SUBJECT: RETRANSMITTAL OF WESTINGHOUSE RESPONSE TO NRC REQUESTS
FOR ADDITIONAL INFORMATION ON THE NOTRUMP COMPUTER CODE

Question 440.326

Re: WCAP-14206 (NOTRUMP CAD)

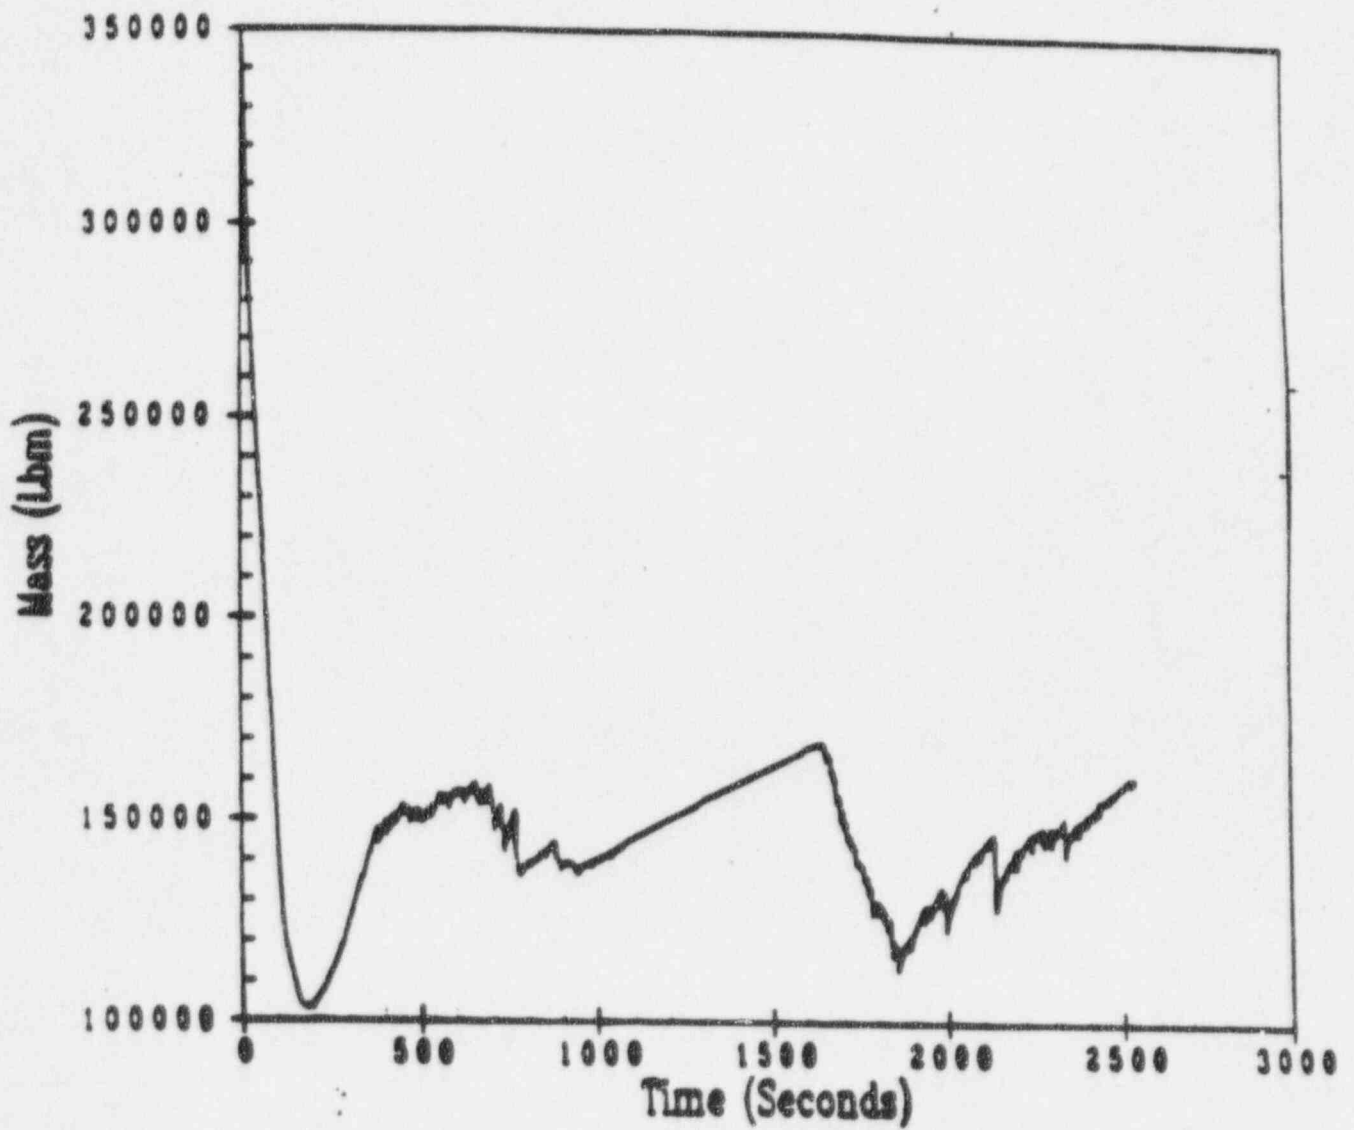
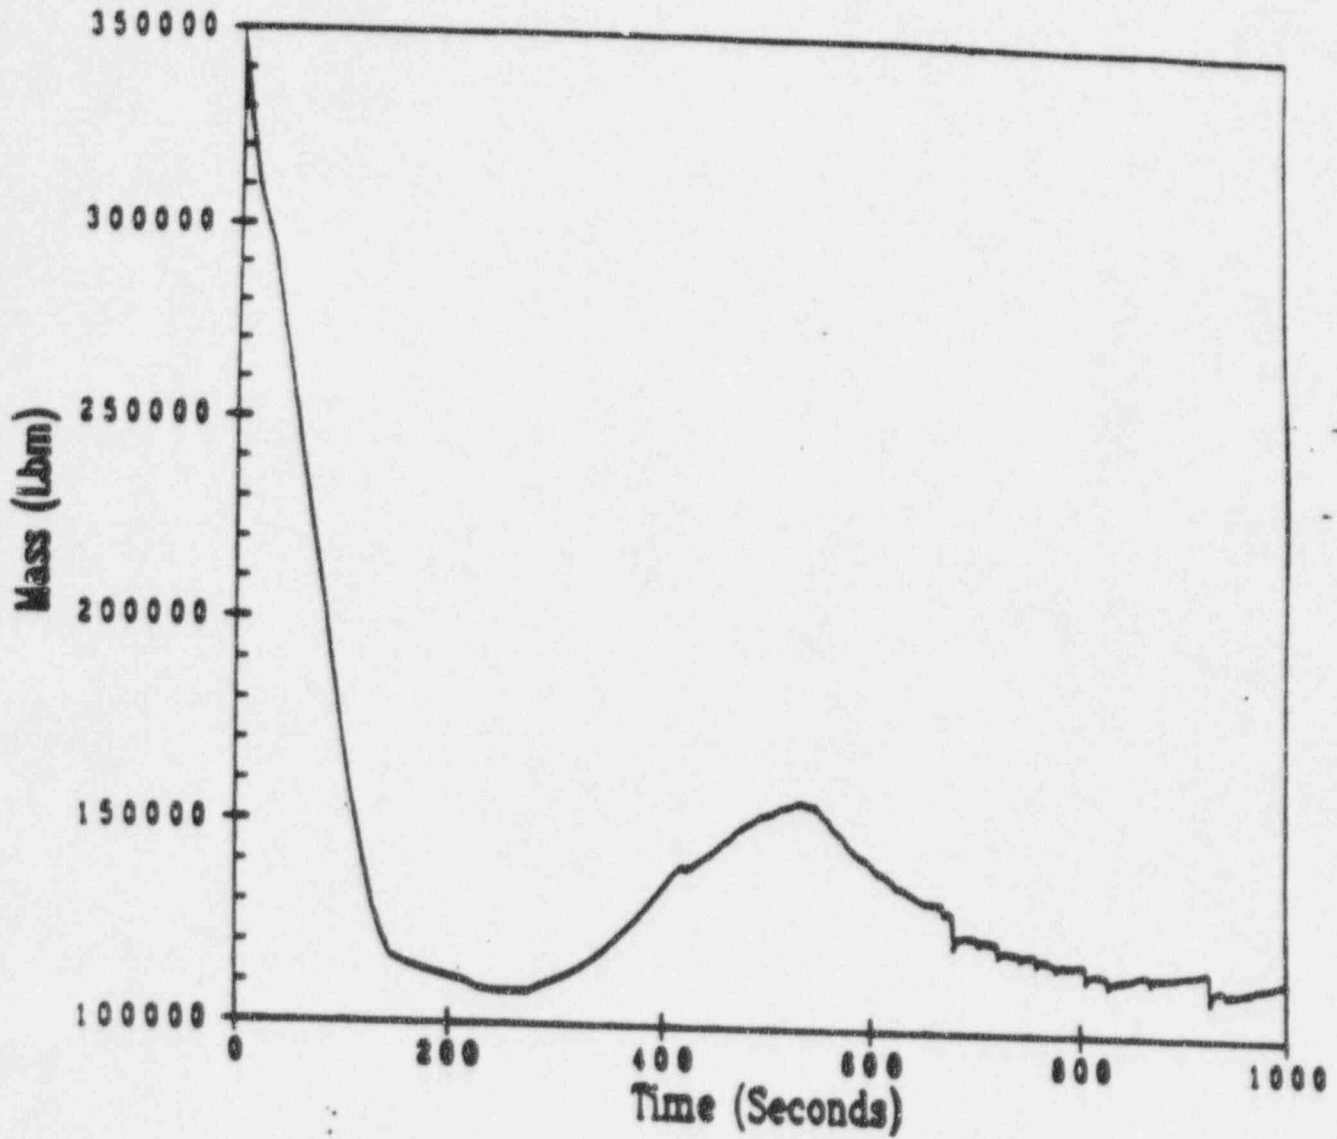
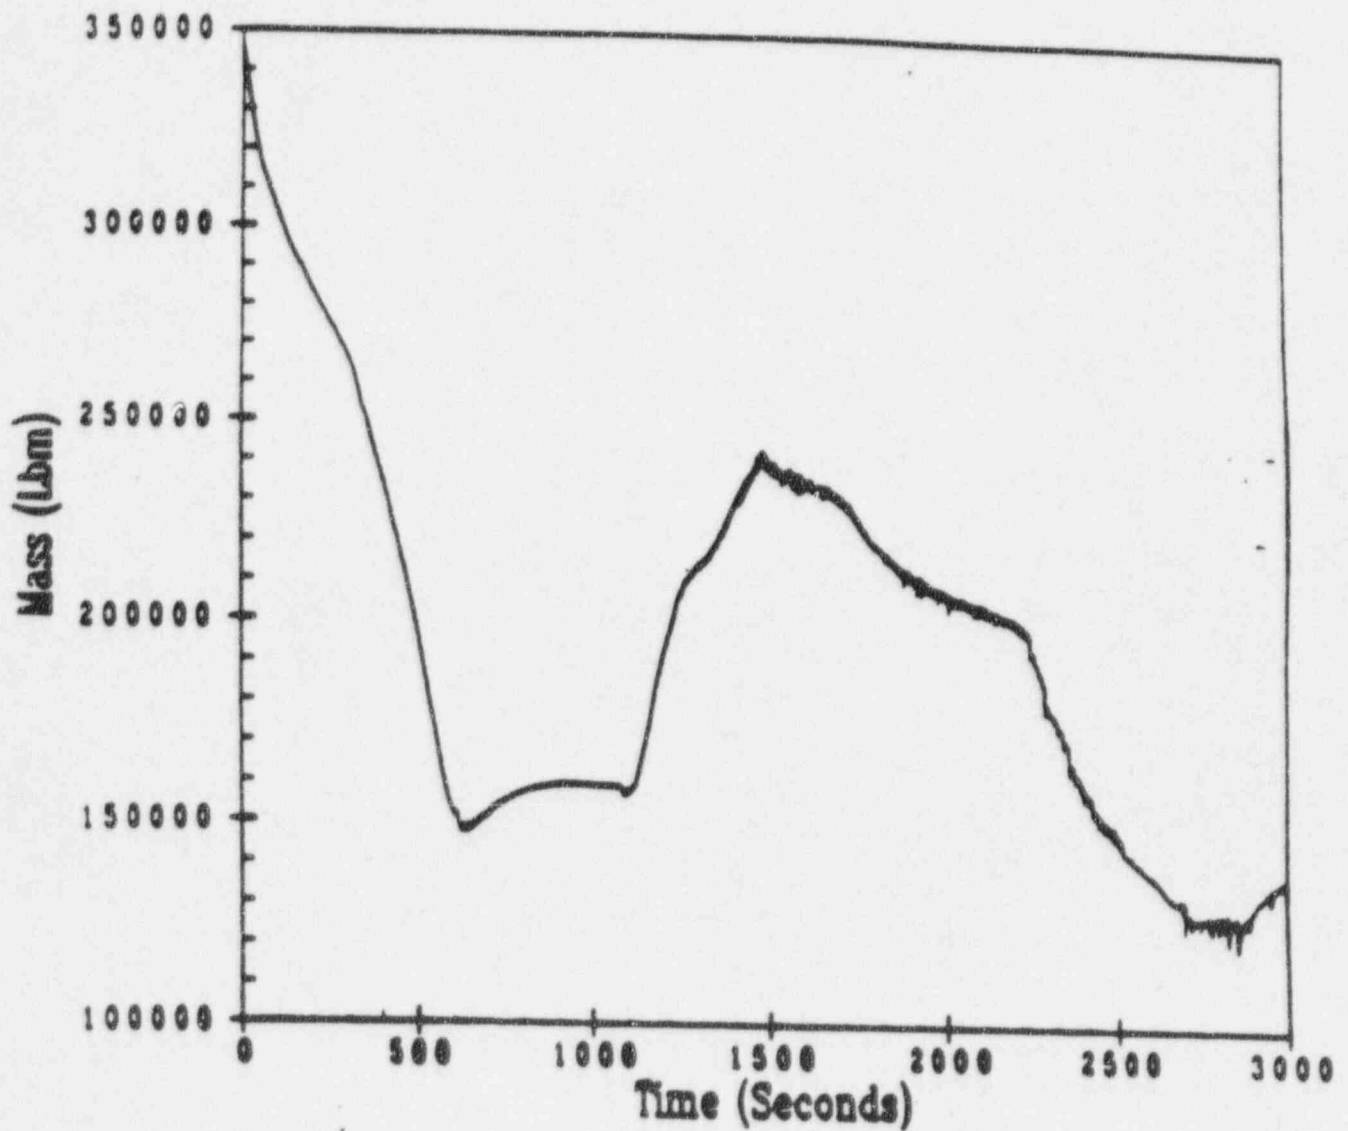
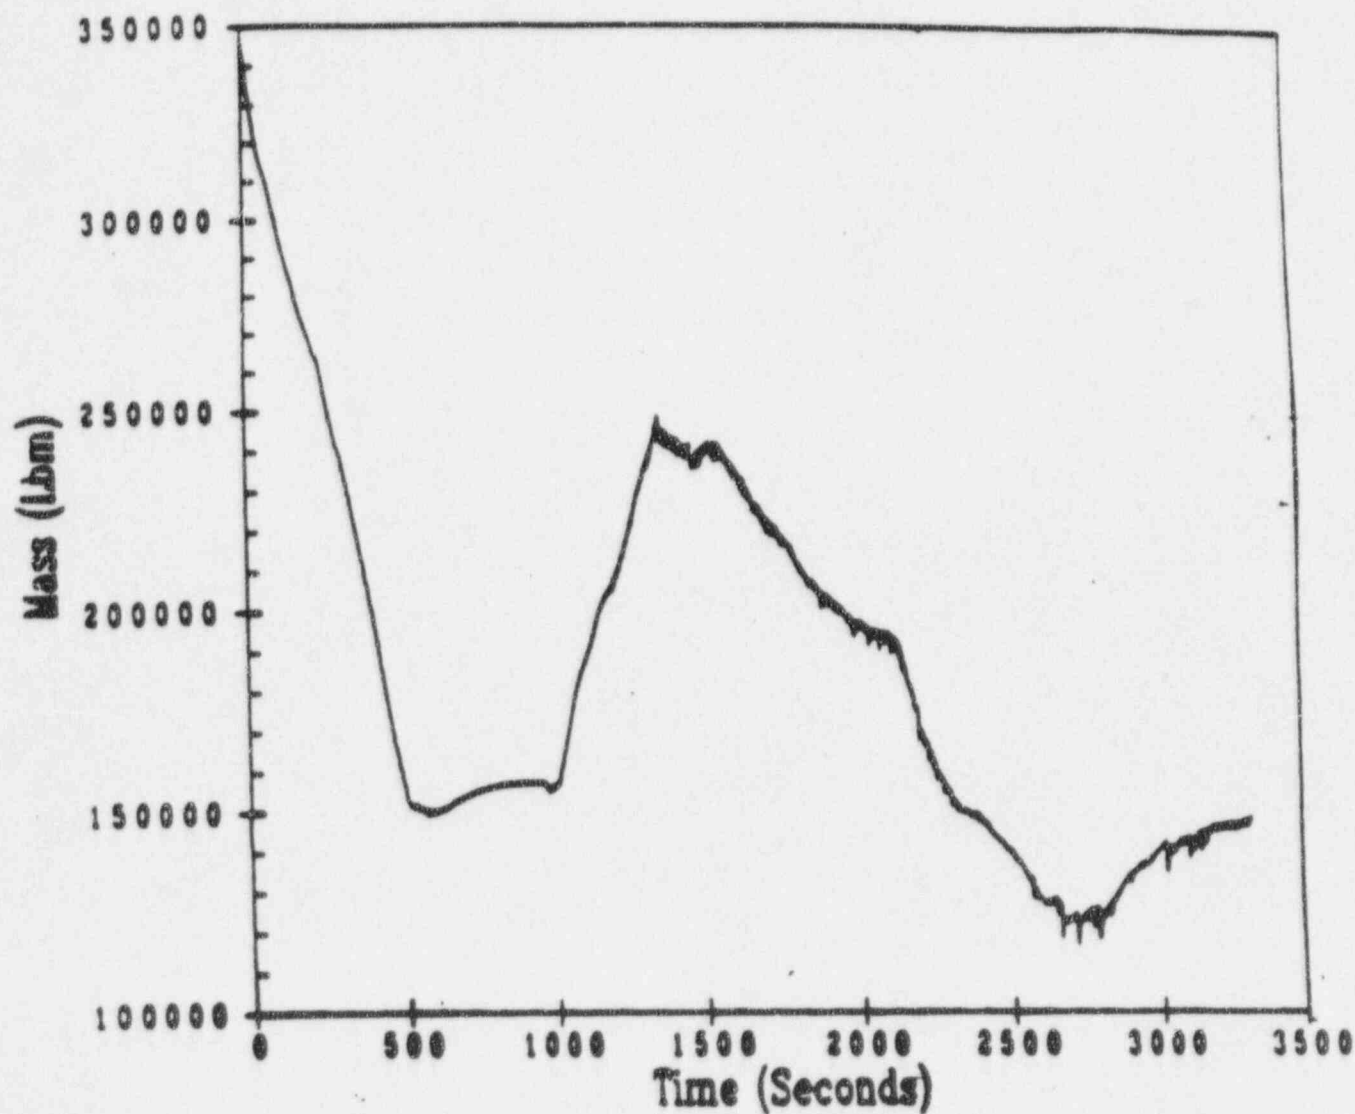
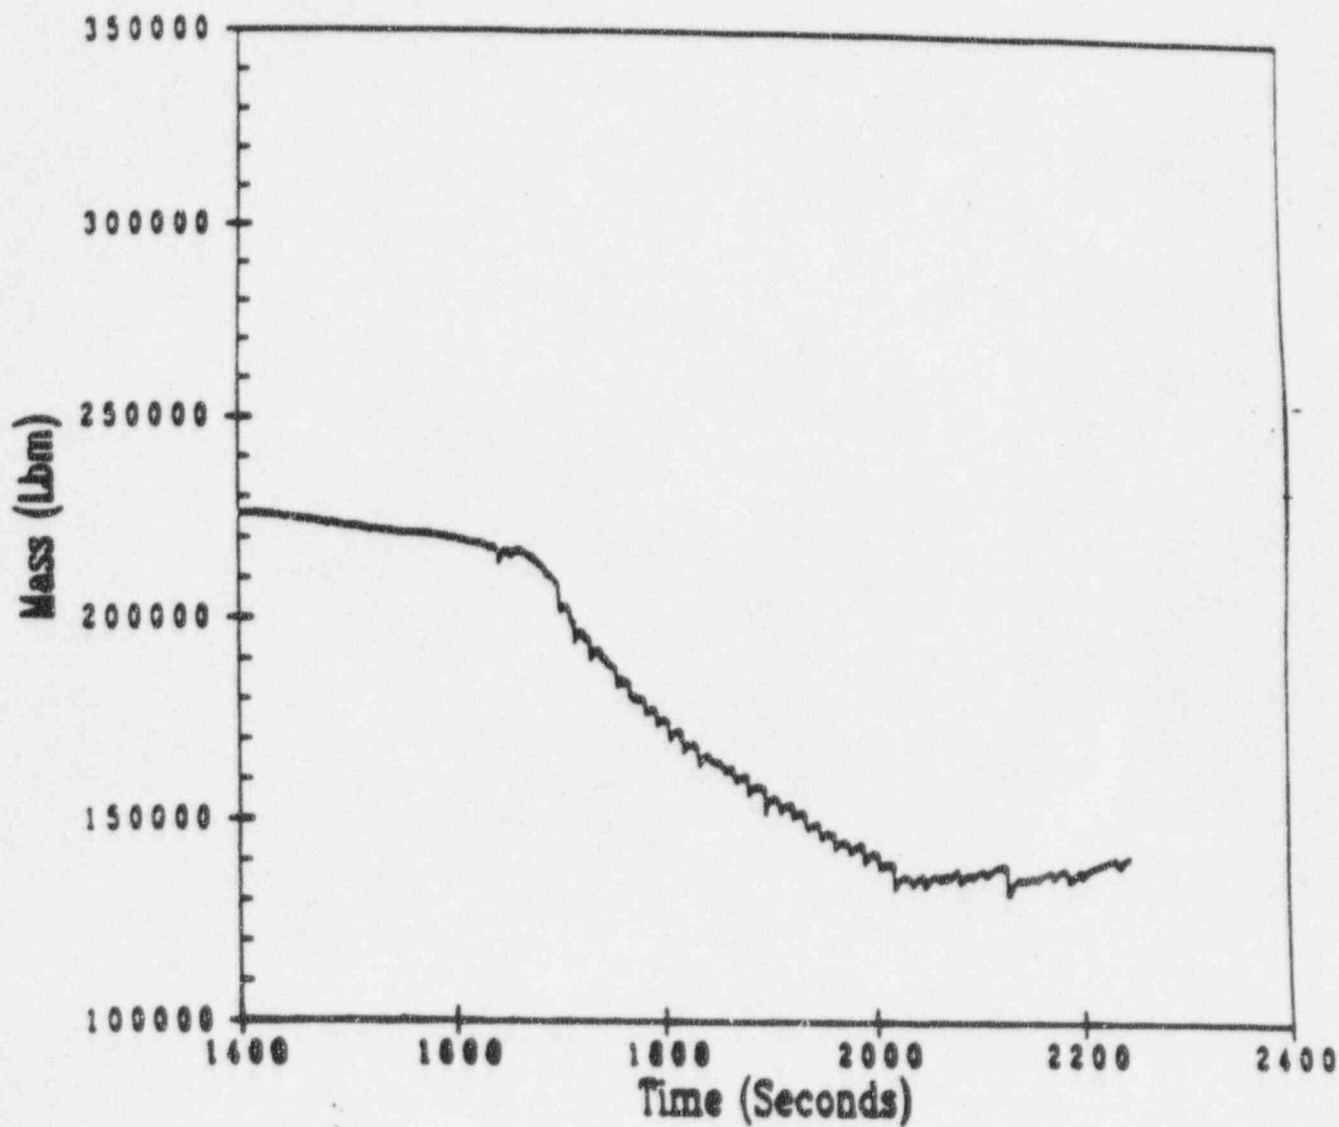
On page 2-5 the limiting failure is a failure of one fourth-stage ADS. Please explain what analyses were performed supporting this conclusion. Also, in view of changes to the ADS, is this still a valid statement? Please explain or provide new information for the limiting failure.

The limiting single active failure in an AP600 small break LOCA analysis depends on the postulated break size and location. In the Reference 440.328-1 break spectrum, the failure of a single fourth-stage ADS valve was modeled in the inadvertent ADS actuation and two-inch cold leg break cases. However, for the double-ended direct vessel injection line break and the double-ended balance line break the postulated failure that renders a single first-stage and a single third-stage ADS valve unavailable is limiting.

The AP600 passive safeguards systems are designed such that no single active failure in either the safety injection or PRHR heat exchanger loops can deprive the reactor of a core makeup tank, accumulator, IRWST or PRHR delivery path. Only failures within the ADS can eliminate safety-related path(s) which otherwise would be in operation during a small break LOCA event. Among the small break LOCAs, the time in the event at which the minimum reactor coolant system mass inventory occurs determines which postulated ADS failure is more limiting. As shown in the attached Figures 440.328-1 and 2, both of the double-ended breaks from Reference 440.328-1 exhibit their minimum RCS mass inventories early in the transient, at about the time at which ADS stage one is activated. Recovery from this minimum mass condition is accomplished via accumulator injection; therefore, if failure of an ADS stage one valve can delay the time at which fully effective accumulator flow is achieved, the minimum RCS mass will be adversely affected for these larger small breaks. Furthermore, the break itself is large enough in these cases to constitute a significant vent path which augments the ADS paths; the degradation in venting associated with the failure of a fourth stage ADS valve is less important in the depressurization of the reactor to achieve IRWST injection. A sensitivity case verified that the postulated stage one/three valve failure is indeed limiting for the AP600 double-ended rupture small break LOCA cases.

In contrast, two-inch cold leg break and inadvertent ADS actuation transients in Reference 440.328-1 exhibit minimum mass inventories (Figures 440.328-3 through 5) when IRWST injection begins. Because depressurizing the reactor to the point at which IRWST injection begins is totally dependent on ADS capability for the smaller small break LOCAs, the postulated failure of one of the largest ADS valves present, a fourth-stage ADS valve, is limiting. Prior to fourth-stage ADS actuation, each of these cases reaches a quasi-equilibrium pressure value which is almost independent of whether a single failure exists among the ADS stage one/two/three valves.
